PUBLIC NOTICE
WOODLAND PARK PLANNING COMMISSION
Thursday, September 12, 2024, 6:30 P.M.
Council Chambers – 220 W. South Avenue

Planning Commission Staff Report PC Public Hearing September 12, 2024

AGENDA ITEM 4A

REVIEW COMMENTS

GRADING PLAN

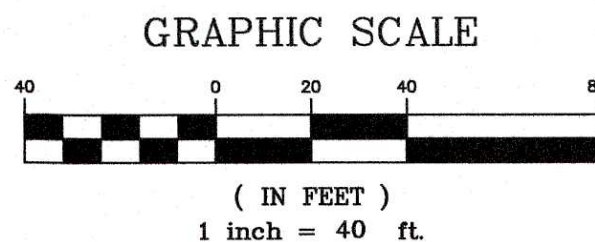
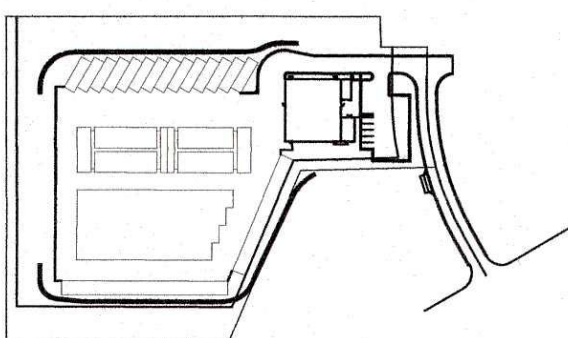
The Utilities Department would not support this request to renew. There has been no movement on the water line crossing under the highway from the original request that was denied. There has also been no movement on this project with submittal of CD's and other plan sets. The owner is also creating a difficult situation with water line connection and access to the property to the south.

Renewal would need conditions that the developer shall improve fountain creek armoring and drainage, per the City of Woodland Park Stormwater Master plan. Integrated in these plans, would be the requirement the developer extend the centennial trail through the property by the creek
